ADDENDUM #1
INVITATION FOR BID #23-77

NEWTON PUMP STATION REHABILITATION PROJECT I

THIS ADDENDUM IS TO: ANSWER THE FOLLOWING QUESTIONS AND TO CHANGE THE BID OPENING DATE AND TIME:

1 480 VOLT MOTOR CONTROL
- NO SCALE

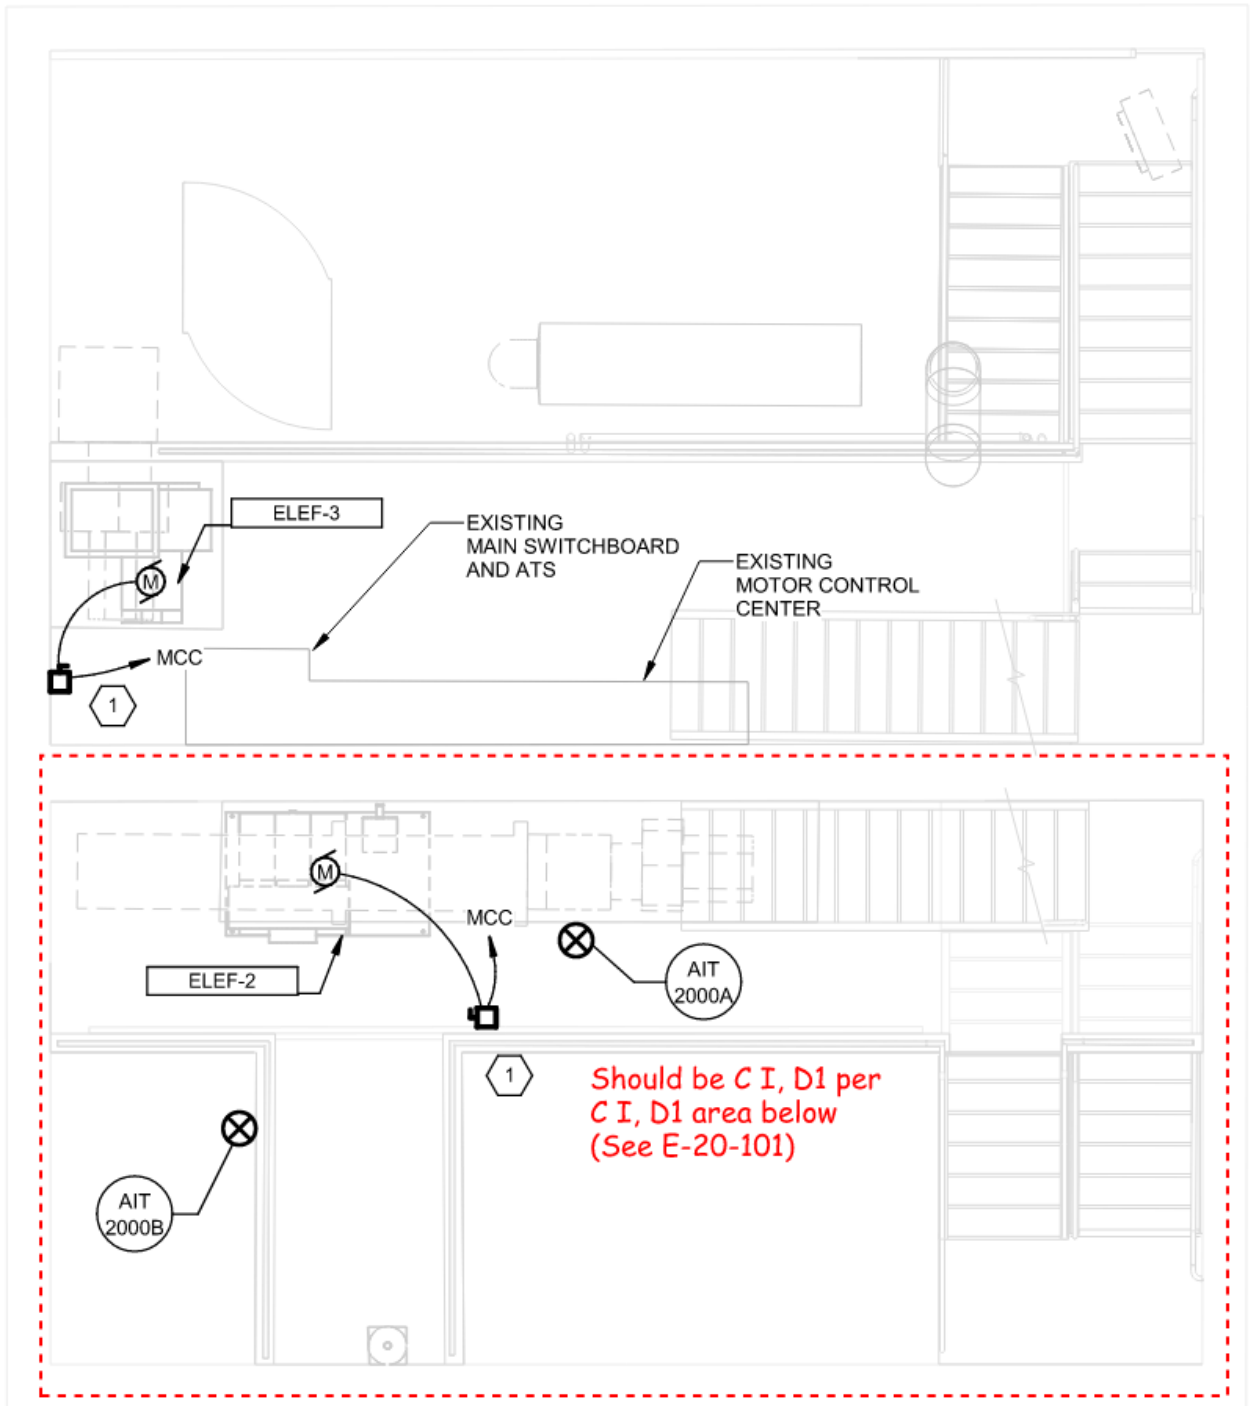
Q7. Drawing E-20-601 shows a new 25A circuit breaker being installed in place of an existing one for ELUH-2. This new MCC circuit breaker is not accounted for on drawing E-20-301 detail 1. Please advise.

A7. The intent is to use the compartment with the existing circuit breaker used for ELUH-2 for the new circuit breaker to feed the new ELUH-2 as indicated on Drawing E-20-601. Refer to photo below for existing circuit breaker location:

1 INTERMEDIATE LEVEL ELECTRICAL PLAN
 SCALE: 1/4" = 1'-0"

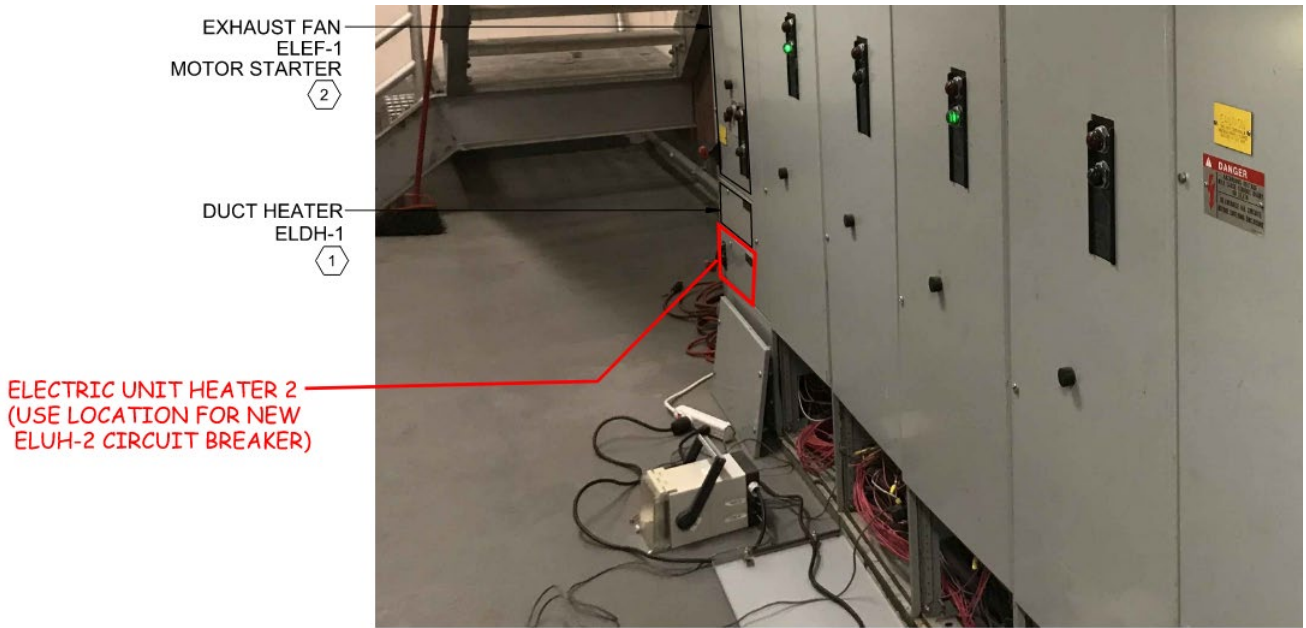
Q5. Please provide area classifications for all areas of each pump station.

A5. Please refer to the Electrical Drawings for area classifications. In addition, please note that the area shown on the next page (from Sheet E-20-102) at Elliot Street PS should be Class I, Division 1:
